H.I Apparels Ltd.

4th August 2019

Observation

Discrepancies between drawings and on-site condition

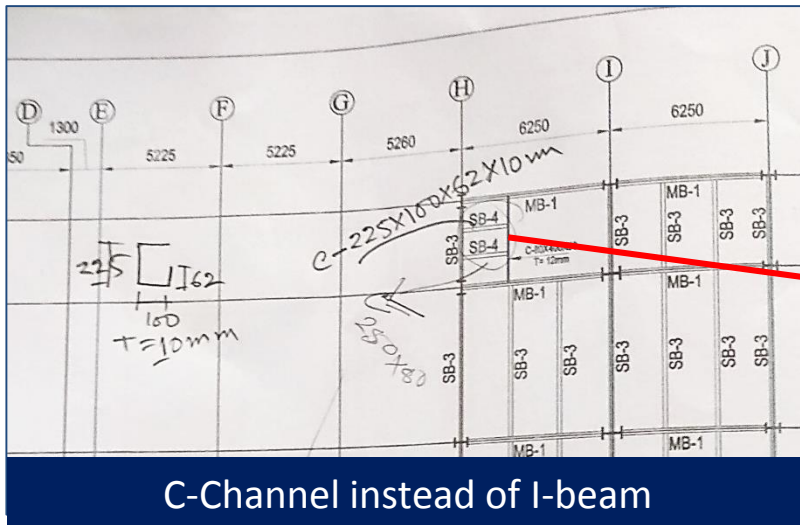
Flange thickness of secondary beam at 3rd floor did not match with the provided drawings. Also, C-channel found instead I-beam at north side stair landing. Building engineer is required to produce an “as constructed” drawings with complete structural information.

12 mm thickness of flange instead of 14 mm

C-channel (225x62x10mm)

Connection rigidity of beam-column joint

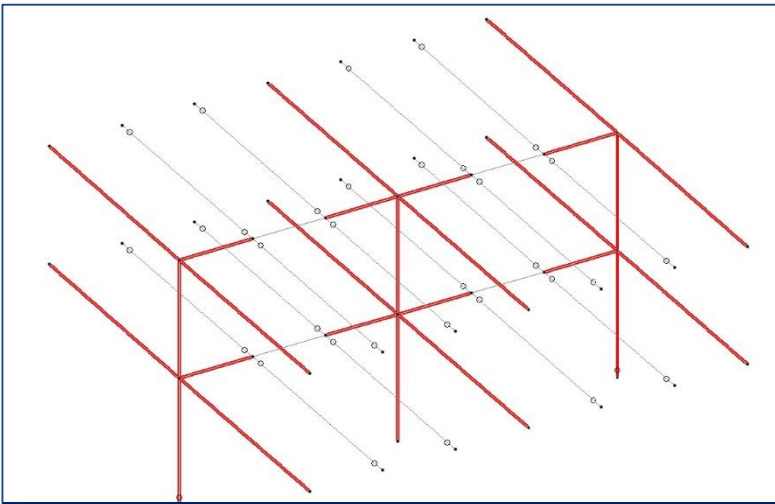
As per the provided Finite Element Analysis (FEA) model, the beam-column connection has been considered as rigid. But the beam detail indicates that the beam ends are not rigidly connected with columns. In addition, the top flange of some framing beams were found cut-off to accommodate the connections. So that, connection rigidity is required to be verified for those beam connections

Top flange found cut near the joint

Prepared DEA report required to be reviewed

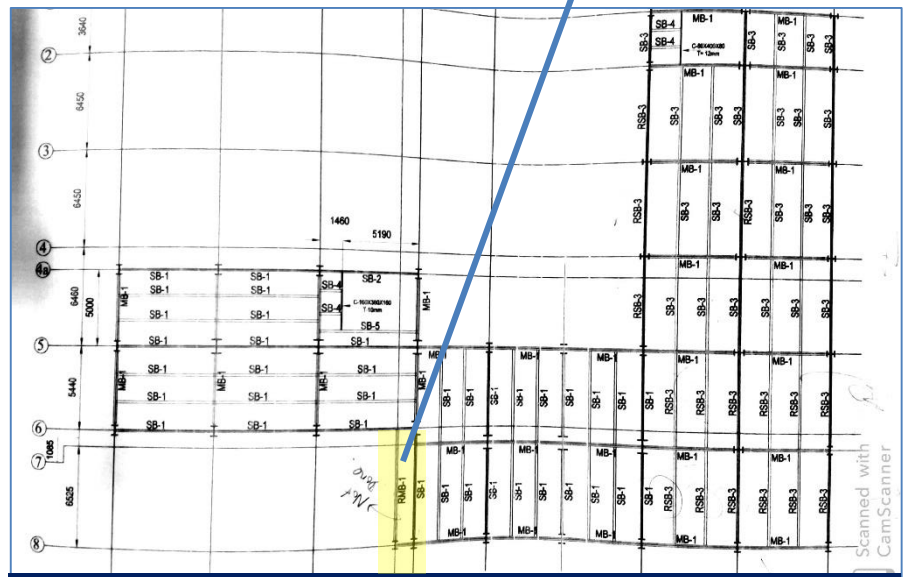
As per the provided DEA report, the factor of Safety (FoS) of some pile foundations are below the allowable limit of 2.50 (BNBC-06, Sec-3.11.1.11). Also, required retrofitting works of secondary beams are not completed marked location. Factory is required to revised the DEA.

Retrofitting not done

Construction fault of deck slab

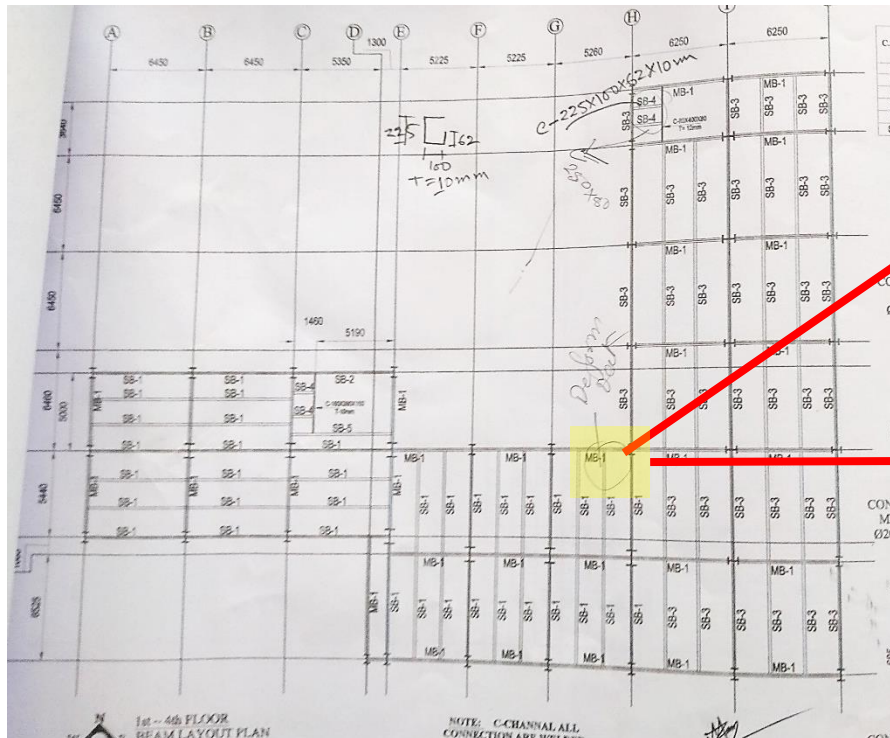
Minor deflection was found at deck slab on 2nd floor roof. Factory engineer is required to monitor the deck slab deflection and keep record.

Deflected portion of deck slab
